AMENDMENT TO FACILITY OPERATING LICENSE

Amendment No. 88
License No. DPR-24

Amendment No. 93
License No. DPR-27

ATTACHMENT TO LICENSE AMENDMENTS

FIGURE 15.3.10-1
 CONTROL BANK INSERTION LIMITS
 POINT BEACH UNITS 1 AND 2

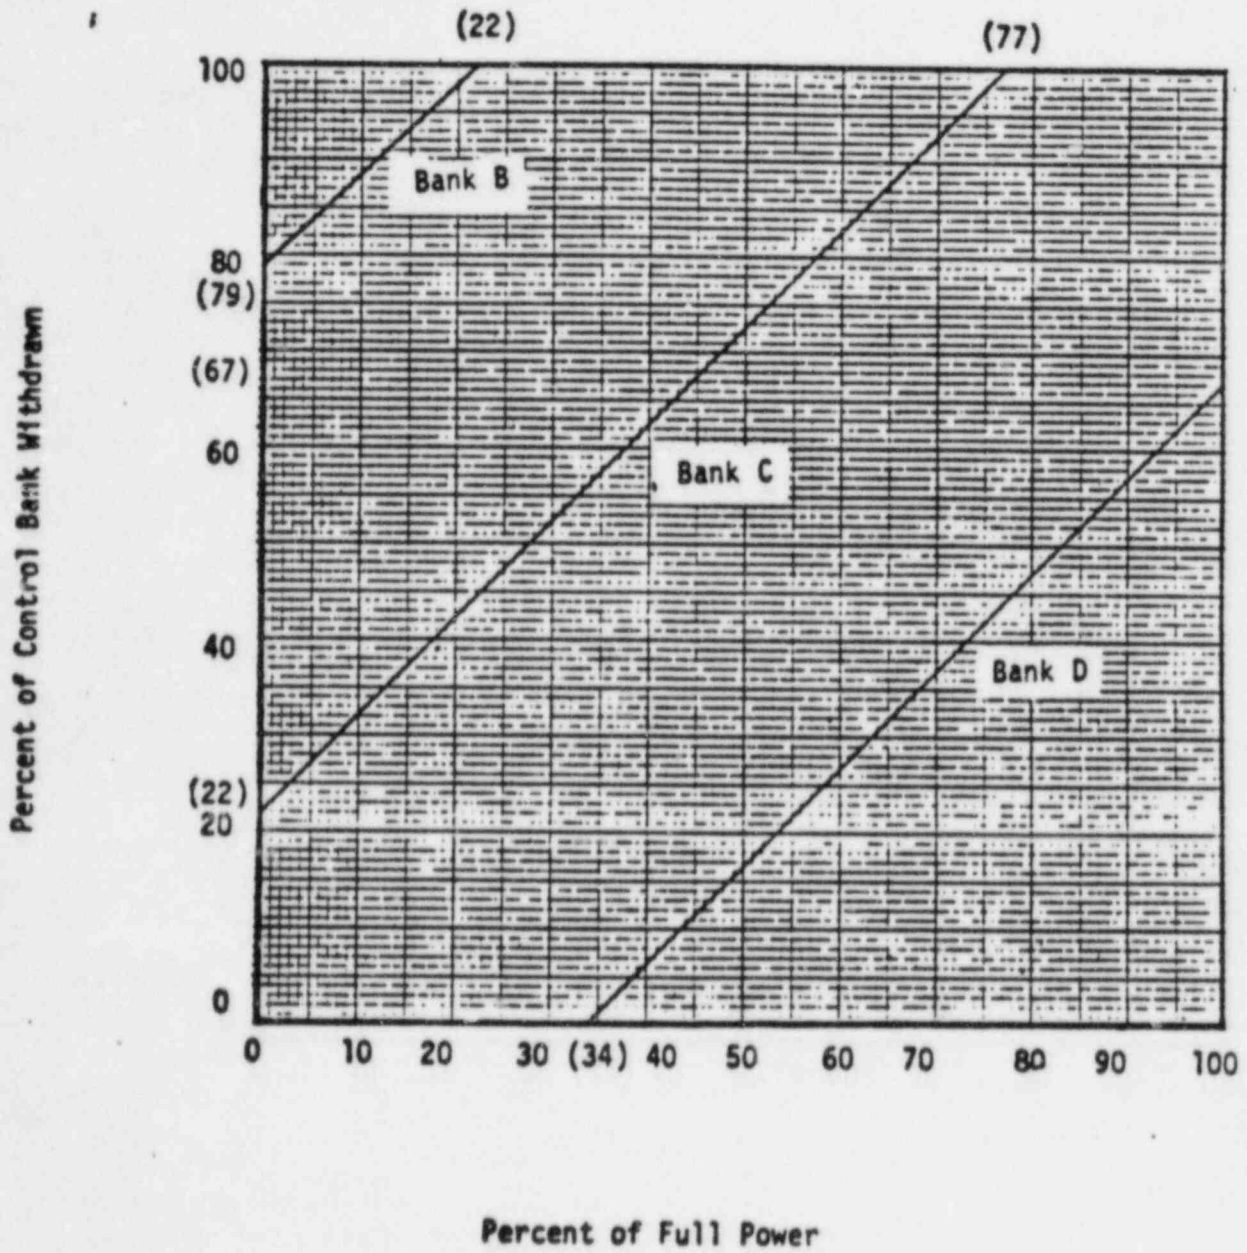
(Units 1 and 2) 15.3.10-1
(Unit 1 only) Figure 15.3.10-1

15.3.10-1
Figure 15.3.10-1

1. When the reactor is critical, except for physics tests and control rod exercises, the shutdown banks shall be fully withdrawn.⁽¹⁾
2. When the reactor is critical, the control banks shall be inserted no further than the limits shown by the lines on Figure 15.3.10-1. Exceptions to the insertion limit are permitted for physics tests and control rod exercises.
